**ORDINANCE NO. 594**

**AN ORDINANCE AMENDING THE WILSONVILLE COMPREHENSIVE PLAN BY ADOPTING THE AMENDED VILLEBOIS VILLAGE MASTER PLAN AS AN ANCILLARY DOCUMENT**

LP2005-02-00006

Figure 2

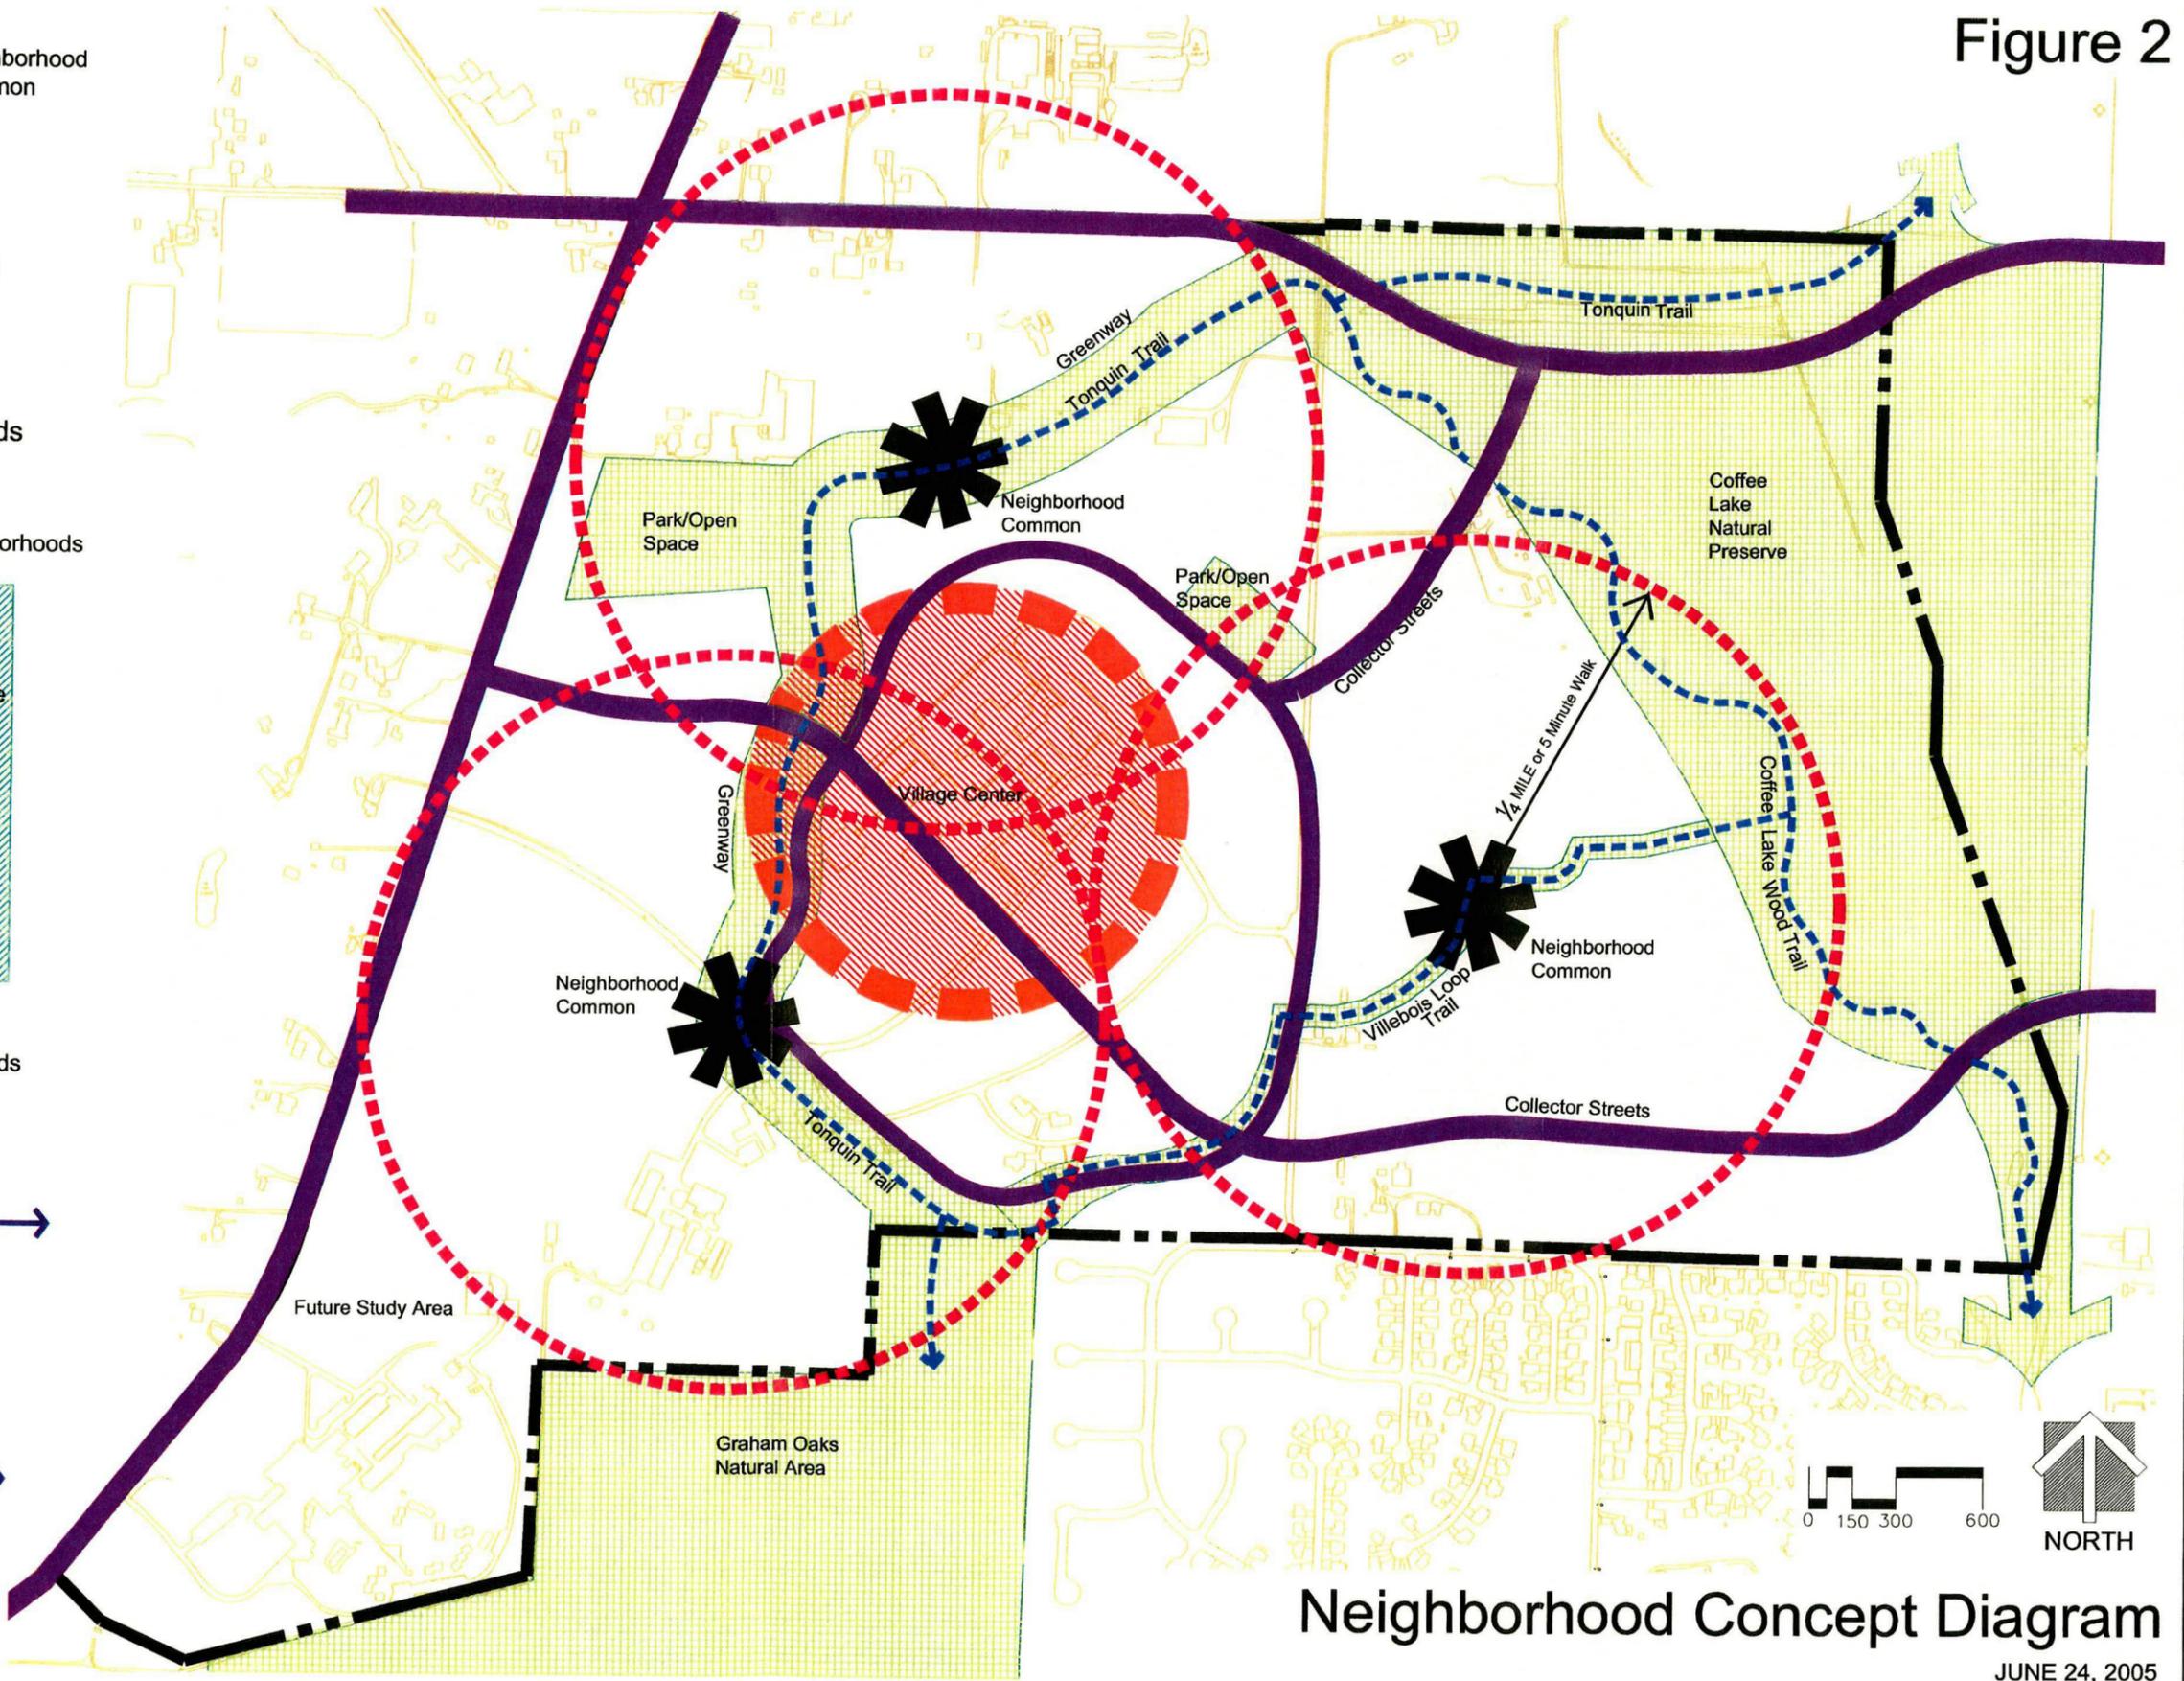
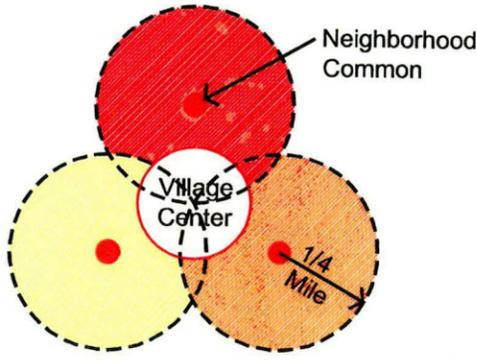
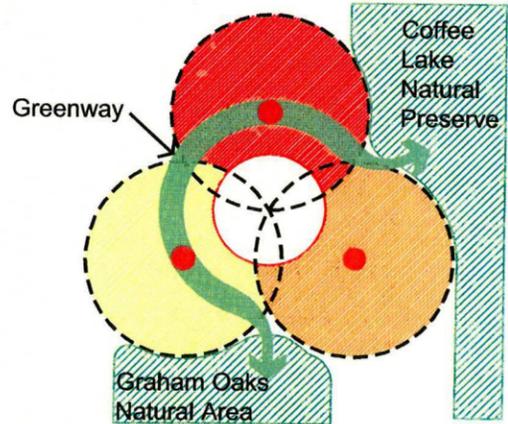
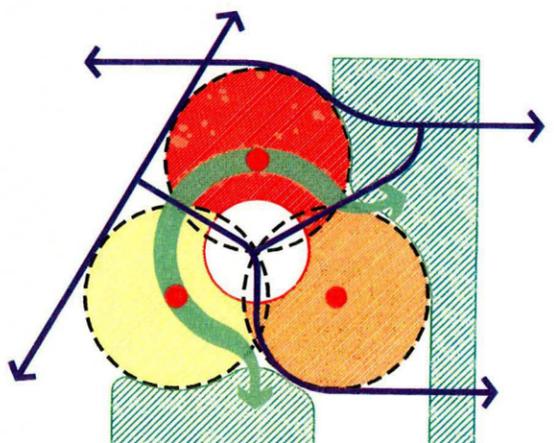
- Figure 2: Adding trail names, the Coffee Lake/Wood Trail running along the west edge of Coffee Lake and the Tonquin Trail following the greenway through Villebois.

- Figure 2: Change in street classification from collector to "Residential-Village Center with bike lanes" for Villebois Drive beginning two blocks from the Loop Road into the Village Center (Exhibit 17).

Figure 2A

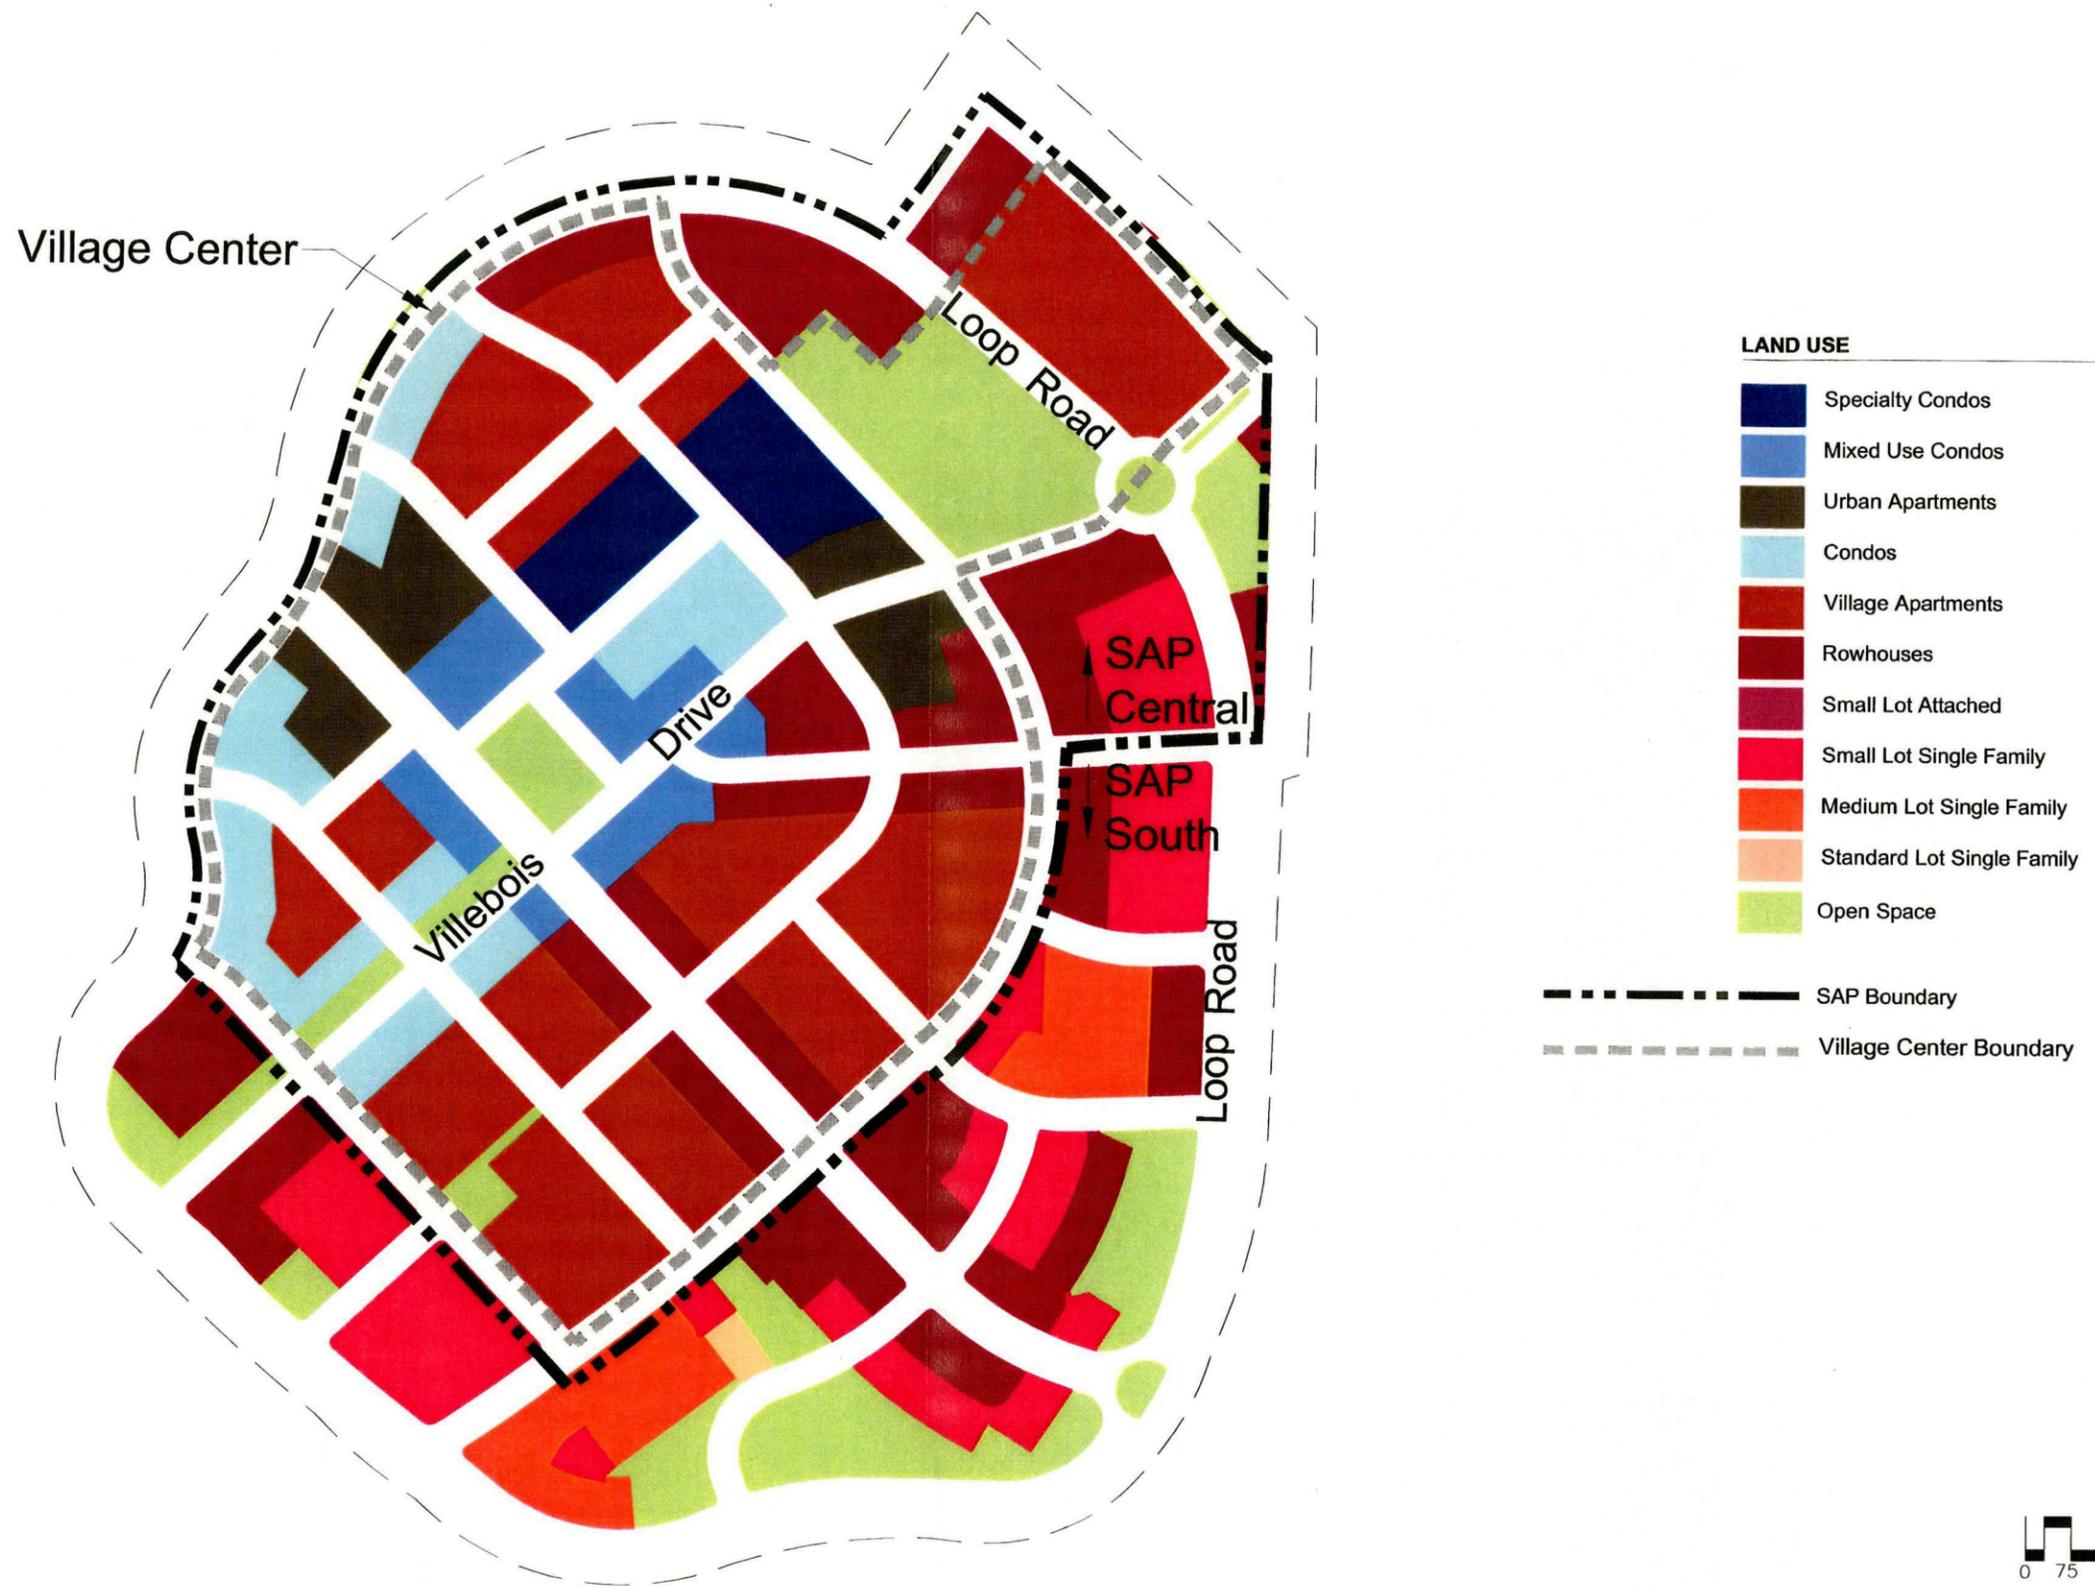
- Figure 2a: Modified street grid, and land use plan.
- Figure 2a: A reduction in the total number of specialty condos, limiting this housing product primarily to the adaptive reuse of Buildings C and D.

- Figure 2a: A redesign of the Village Center Linear Green that now connects West Neighborhood Park and the Greenway with the Village Center Plaza and a new configuration for the Village Center Plaza surrounding it by streets.
